SUBJECT: DUANE ARNOLD ENERGY CENTER - ISSUANCE OF AMENDMENT  
REGARDING STANDBY LIQUID CONTROL MINIMUM BORON  
CONCENTRATION (TAC NO. MB0102)

Amendment No. 236  
License No. DPR-49

RELATED TO AMENDMENT NO. 236 TO FACILITY OPERATING LICENSE NO. DPR-49

Figure 3.1.7-1 (page 1 of 1)  
Sodium Pentaborate Solution Volume  
Versus Concentration Requirements

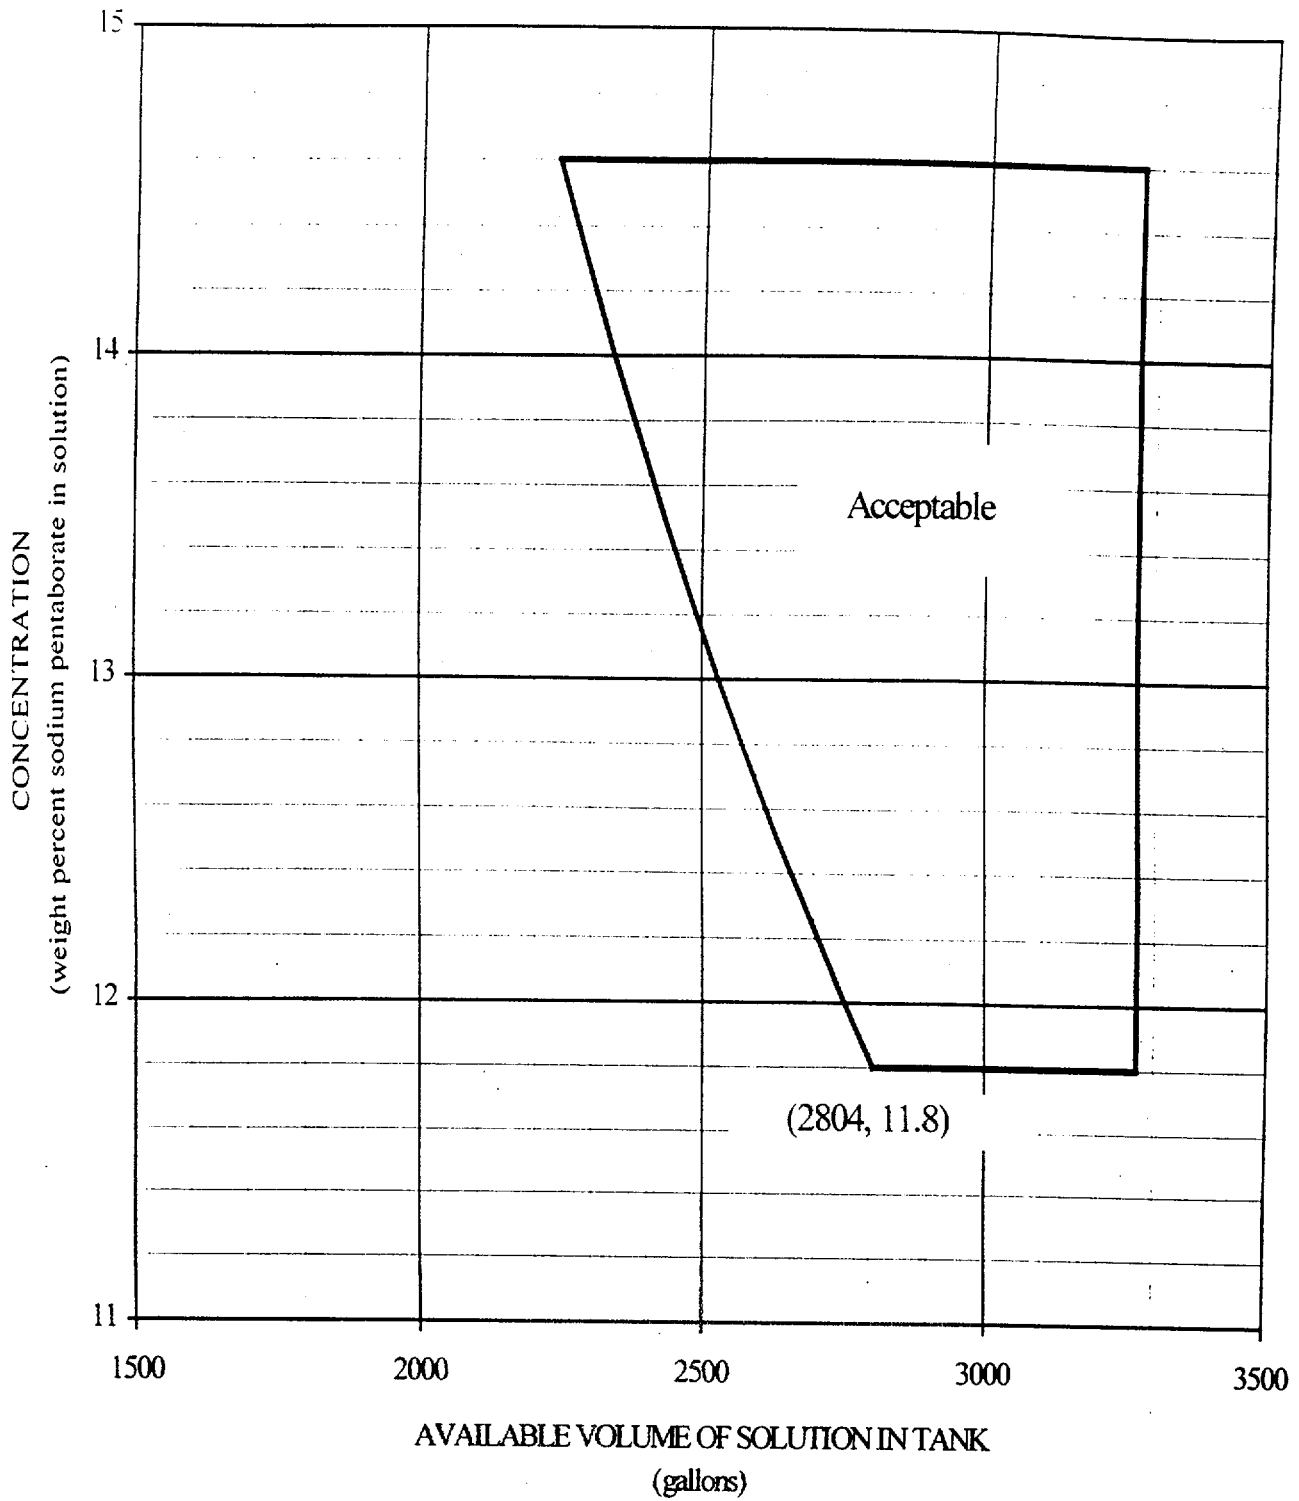
The amendment revises the Standby Liquid Control boron solution requirements in TS Figure 3.1.7-1 to ensure a minimum boron concentration of 660 parts per million in the reactor.

The DAEC TS include surveillance requirement 3.1.7.1 which requires that the available volume of boron solution in the SLC tank be within the limits of TS Figure 3.1.7-1. DAEC TS surveillance requirement 3.1.7.5 requires that the concentration of boron in solution be within the limits of TS Figure 3.1.7-1. The licensee has proposed to modify TS Figure 3.1.7-1 to contain the acceptable volume and concentration values which would result in a minimum boron concentration of 660 ppm consistent with the results of GE's analysis. An additional 25 percent of the quantity of boron required to achieve a minimum boron concentration of 660 ppm in the reactor will also be injected, maintaining the margin which compensates for imperfect mixing and potential leakage in the reactor system.

The licensee has also proposed a change to clarify TS Figure 3.1.7-1. Figure 3.1.7-1 is currently titled "Gross Volume of Solution in Tank." Since the SLC tank outlet is above the bottom of the tank, the gross volume in the tank is not available for injection in the reactor. The licensee has proposed to change the title of Figure 3.1.7-1 to "Available Volume of Solution in the Tank." This change corrects a potential inconsistency in the TS, and is therefore, acceptable.

The staff has reviewed the licensee's submittal. The analysis performed by GE to support the amendment request was performed using approved methods, and the licensee has demonstrated that the proposed minimum boron concentration ensures that sufficient shutdown margin will be maintained and the SLC system will continue to comply with the requirements of 10 CFR 50.62 for ATWS. Therefore, the staff finds the proposed change to be acceptable.

The staff has reviewed the licensee's proposed changes to TS Figure 3.1.7-1 and the associated Bases section related to the standby liquid control boron solution requirements. Based on the review, the staff concludes that the proposed TS changes are acceptable.
